Subject: Duke Energy Carolinas, LLC
William States Lee III Nuclear Station - Docket Nos. 52-018 and 52-019
AP1000 Combined License Application for the
William States Lee III Nuclear Station Units 1 and 2
Response to Request for Additional Information
Ltr# WLG2008.11-26

Lee Nuclear Station Response to Request for Additional Information (RAI)

Reference NRC RAI Numbers: ER RAIs 11 and 62

**Subject: Proposed William States Lee III Nuclear Station
Discharge Pipe Sedimentation Analysis Report**

FIGURE 2
WATER VELOCITY VECTORS IN LOWER NINETY-NINE ISLANDS RESERVOIR WITH ONE UNIT OPERATING

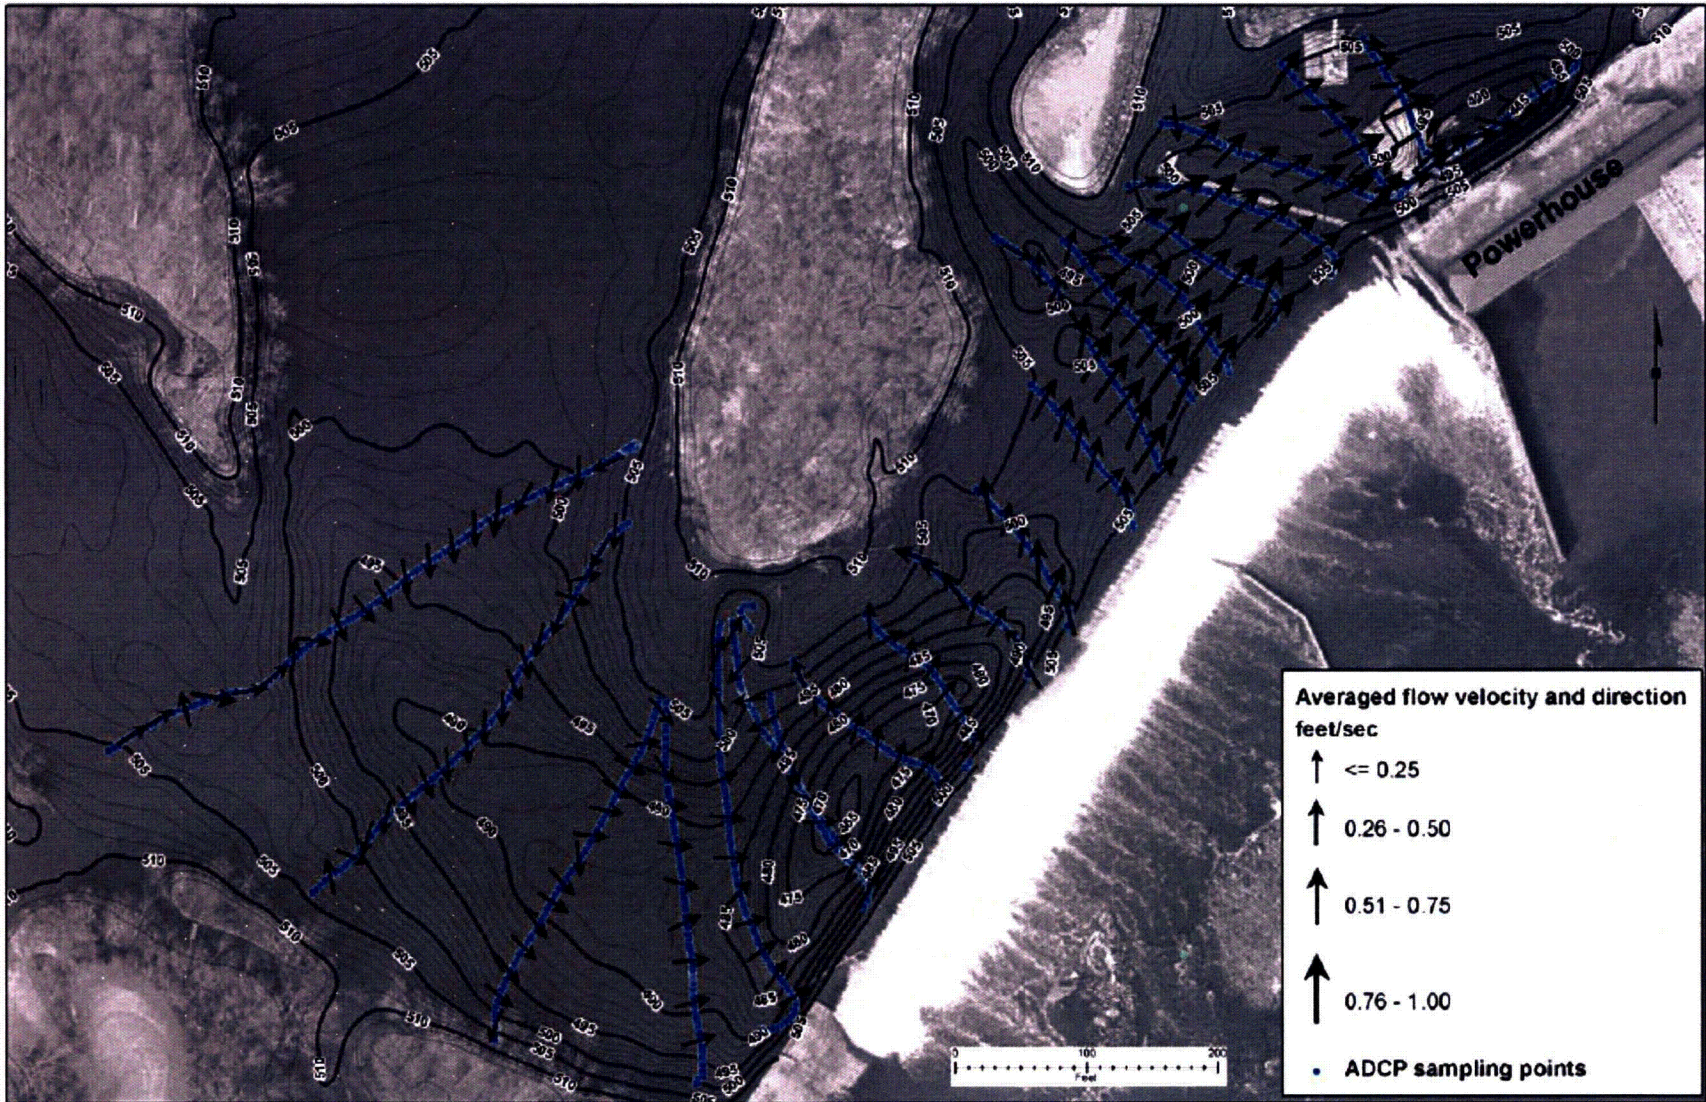
Under one-unit hydro generation, velocities near the diffuser end of the wastewater discharge pipe range from 0.25 to 1.0 ft/s, which should be adequate to prevent sediment from settling on the pipe.

Under one-unit hydro generation (Figure 2), velocities near the diffuser end of the wastewater discharge pipe range from 0.25 to 1.0 ft/s, which should be adequate to prevent sediment from settling on the pipe when the pipe is not discharging wastewater.

FIGURE 3
WATER VELOCITY VECTORS IN LOWER NINETY-NINE ISLANDS RESERVOIR WITH NO UNITS OPERATING

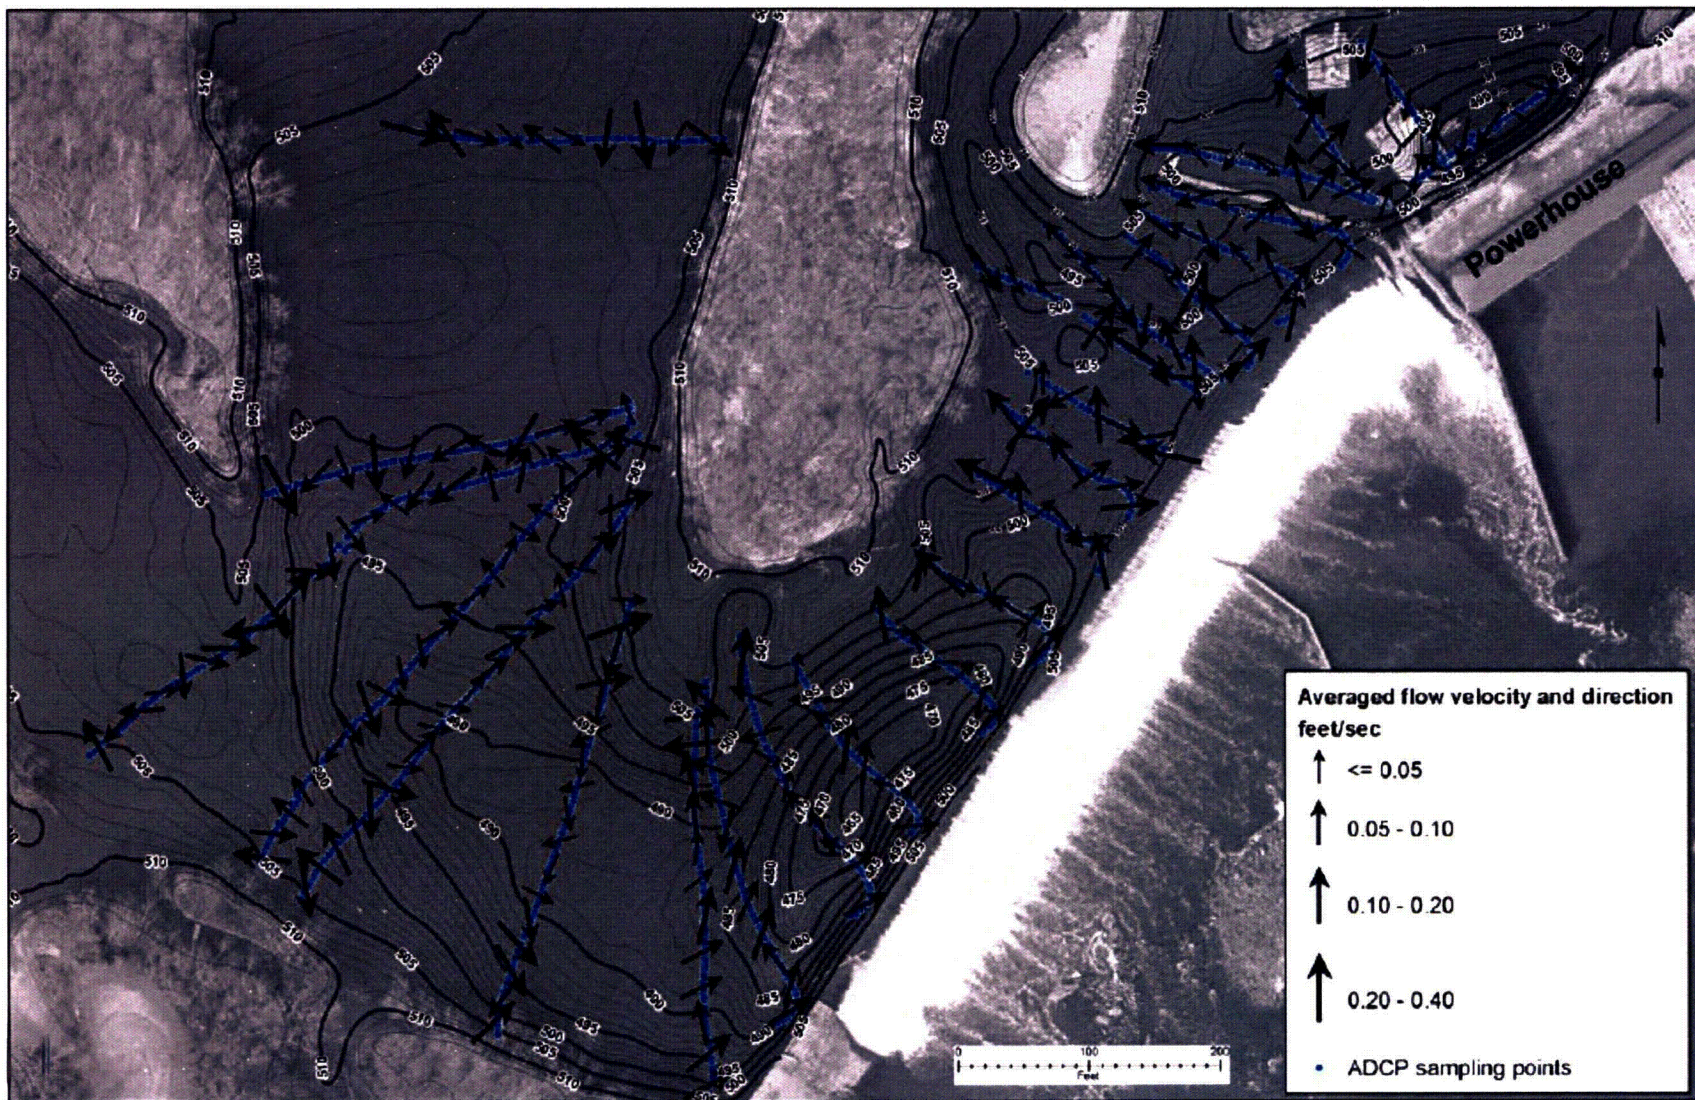
Under the no hydro generation scenario, a hydraulic eddy forms in the area of the wastewater discharge pipe and sediment deposition during these periods may occur. It should be noted that even under the no hydro generation scenario, leakage occurs through the hydro units' wicket gates therefore some continuous flow will always be released from the units but this flow is being ignored for this evaluation. Based on the configuration of Ninety-Nine Islands Reservoir and the bathymetry of the reservoir near the dam, it is likely that the majority of sediments will settle out along the deepest portion of the reservoir forebay away from the diffuser end of the pipe.

Under the no hydro generation scenario (Figure 3), a hydraulic eddy forms in the area of the wastewater discharge pipe and sediment deposition during these periods may occur. It should be noted that even under the no hydro generation scenario, leakage occurs through the hydro units' wicket gates. This is being ignored for this analysis. In order to determine how much sediment may be available during these low flow periods, TSS versus flow data was plotted for 2007 (the year in which twice per month TSS data was collected). This relationship is shown in Figure 4. For flows less than 1,800 cfs, it was conservatively assumed that TSS = 20 mg/L based on the field data collected during 2007. For flows higher than 1,800 cfs, Microsoft Excel software was used to determine a linear equation for the relationship between flow and TSS. The resulting equation is:
